Westfield Penrith Mondo Scheme 11 Access Report

This Access Australia (AA) Report relates to instructions and documents received to date from Scentre Group regarding Penrith Mondo at the Westfield Penrith Shopping Centre, Penrith NSW.

Basement 'accessible' parking

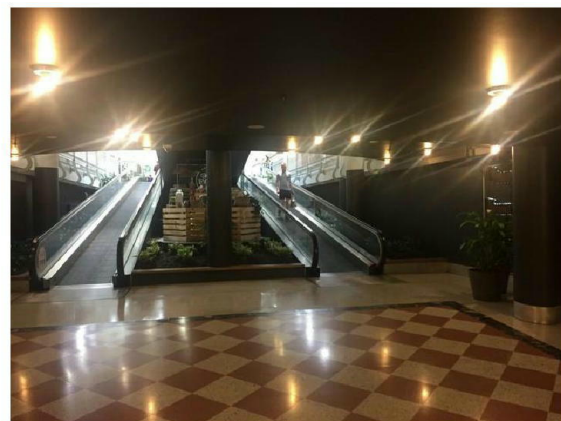
Basement car park provides 13 non-complying 'accessible' car spaces 4000± wide with 2800± ceiling height. There are no adjacent shared spaces.

The accessible car spaces have generally level access to 1700± wide automatic entry doors, with travelators and non-complying ramps to upper levels. Travelators are not part of an accessible path of travel and lift access is not provided.

Existing Entry & Car parking	Access criteria APS, BCA & Standards
Paths of travel (POT) Entries and signage	Provide continuous accessible POT between property boundaries, main pedestrian entrances and associated areas
	Provide consistent accessible signage
	Comply with Penrith DCP 2014 including minimum 2.5m wide footpaths
Accessible parking	Provide complying lift or ramp access to retail areas
	Provide AS4299 and NCC / BCA complying accessible parking including minimum 2.4m wide accessible parking spaces with adjacent 2.4m wide shared spaces, complying with the BCA and AS2890.6-2009
	Provide maximum 1:40 cross fall, minimum 2.2m driveway height, minimum 2.5m parking space height, and install ISA (International Symbol of Access) ground and vertical signage and accessible POT

Non-complying car parking ramps

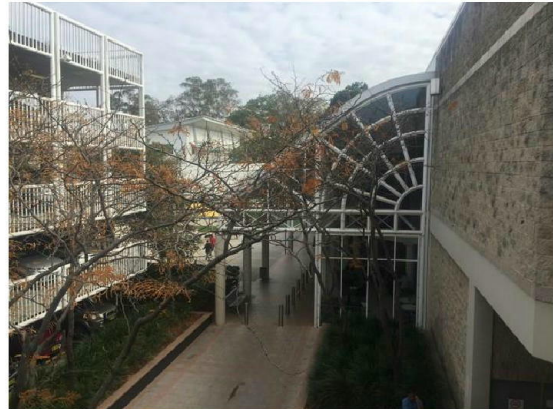
Access to Level 2 is provided by travelators, escalators and non-complying ramps within the car parking structure.

Existing Level 2	Access criteria APS, BCA & Standards
Paths of travel (POT) Entries and signage	Refer Level 1 / Ground requirements
Accessible parking	Refer Entry & Car parking
Signage	Provide consistent accessible signage

Level 1 proposed works

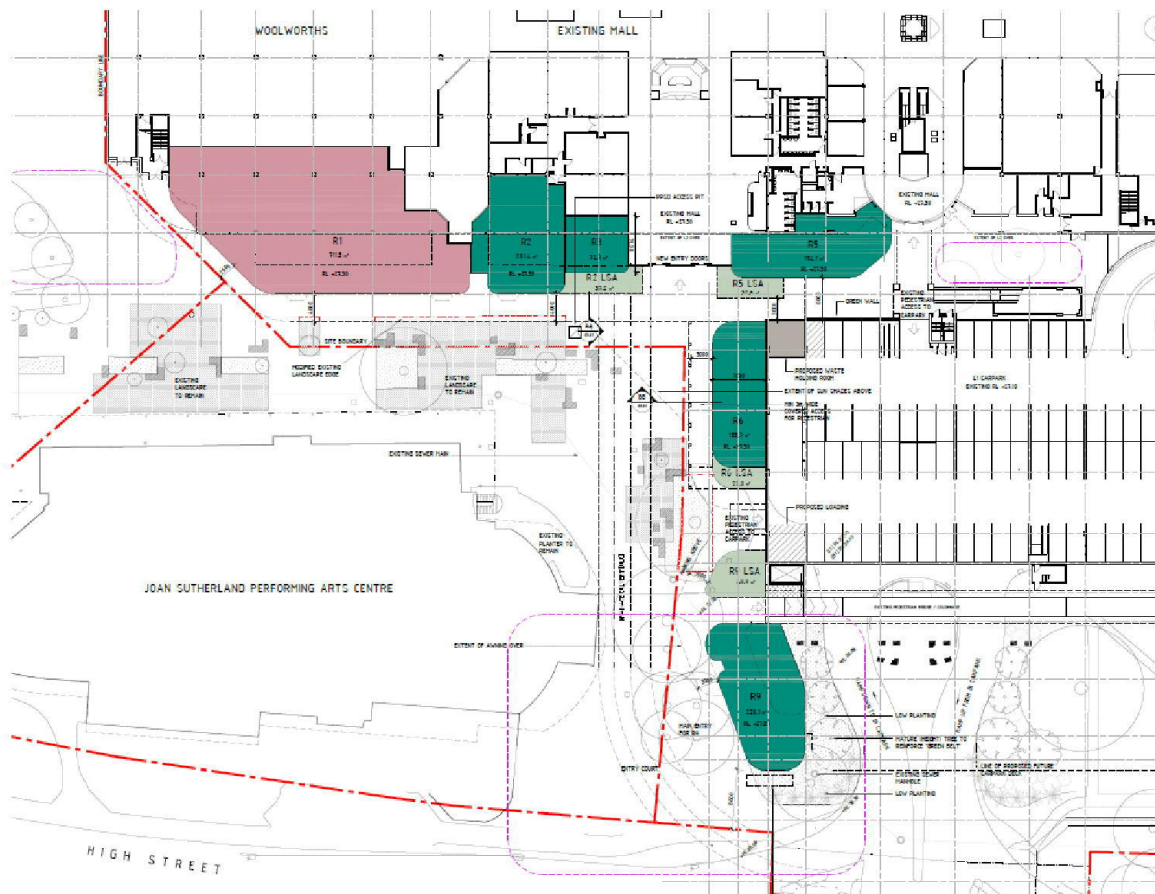
Proposed works include 3m± wide entry walkways and retail areas with external ground level access.

Penrith Mondo Level 1 / Ground	Access criteria APS, BCA & Standards
Paths of travel (POT) and entries	<p>Provide accessible POTs between main entrance, lift lobby and carparking, and minimum 850 doors with complying nibs and circulation</p> <p>Provide complying stairs, ramps and tactile indicators</p> <p>Glazed entry doors to include continuous decals 75mm± and 900 to 1000mm high with minimum 30% luminance contrast between decals and background</p> <p>Comply with Penrith DCP 2014 including minimum 2.5m wide footpaths</p>
Accessible parking	Refer Entry & Car parking
Passenger lift	<p>Passenger lift to provide complying circulation space, minimum 900 wide door and minimum 1100 x 1400 car size, Braille & tactile controls 900 to 1200 high, handrails adjacent to controls and audio announcements</p>
Fixtures, fittings and equipment FF&E)	<p>Provide an equitable range of accessible FF&E including minimum 1m wide section of accessible counters</p>

Amenities	<p>Install NCC / BCA complying accessible facilities where gender specific amenities are provided</p>
Public domain	<p>Provide accessible paths of travel</p> <p>Minimum 20% of seating to comply with AS1428.2 including seat backs and armrests</p>
Signage	<p>Install consistent and accessible identifying signage with minimum 30% luminance contrast between signage and background</p>
